UNITED STATES PATENT AND TRADEMARK OFFICE

10/573,467

Office Action Summary	Application No. 10/573,467	Applicant(s) KOBAYASHI ET AL.	
	Examiner PAUL E. PATTON	Art Unit 2822

DETAILED ACTION

Fig.1**Fig.3**

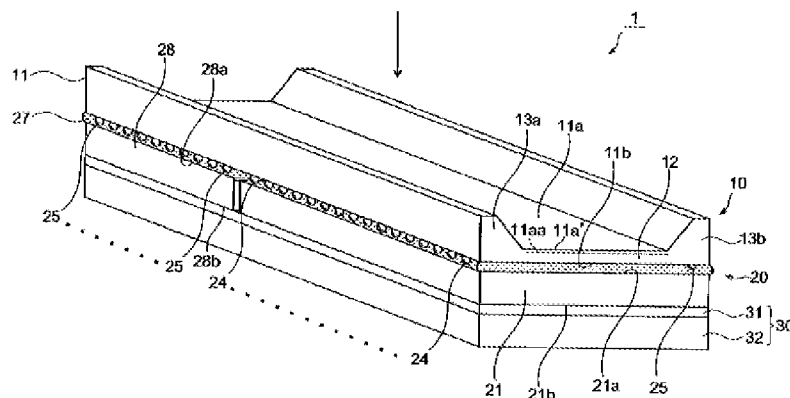
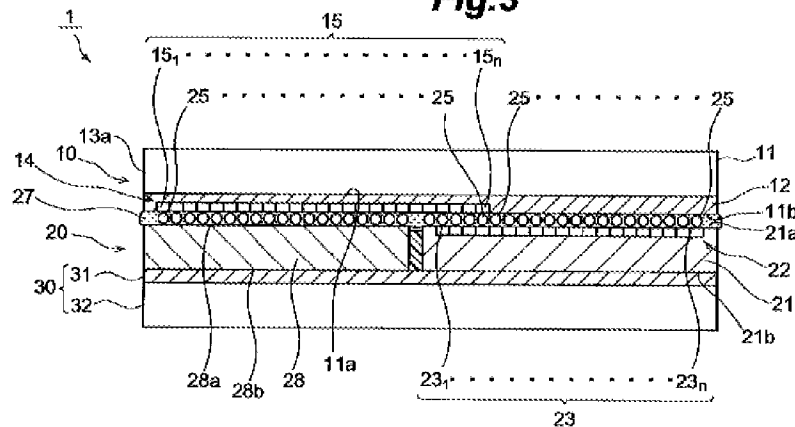
4. As to claims 1 and 3, Muramatsu discloses and shows (Figs 1 & 3) a semiconductor 13b having a photodetecting unit (11) formed on one surface, a thinned portion formed by etching a region, opposing a photodetecting unit, of another surface, and first electrodes disposed on the one surface of an outer edge of the thinned portion and electrically connected to the photodetecting unit; a wiring substrate (21) disposed to oppose the one surface side of the semiconductor substrate and having second

electrodes (23) connected via conductive bumps (25) to the first electrodes; and a resin (27), filling a gap between the wiring substrate and the outer edge of the thinned portion to reinforce the strength of bonding of the respective first electrodes and the respective second electrodes with the conductive bumps.

Fig. 1

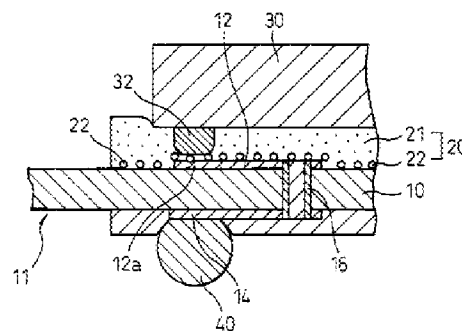
6. Higashi discloses and shows (Higashi, Fig 1) the resin is a resin sheet that is formed in advance so as to surround a periphery of a gap between the thinned portion and the wiring substrate, adhering the sheet to a predetermined region on the other surface of the substrate and thermo-compression bonding the semiconductor substrate with the resin sheet to the wiring substrate. (Column 3, line 37 – column 4, line 43, see also the entire patent).

7. Higashi is evidence that a person of ordinary skill in the art would find a reason, suggestion or motivation to use a resin sheet that is formed in advance so as to surround a periphery of a gap between the thinned portion and the wiring substrate, adhering the sheet to a predetermined region on the other surface of the substrate and thermo-compression bonding the semiconductor substrate with the resin sheet to the wiring substrate.
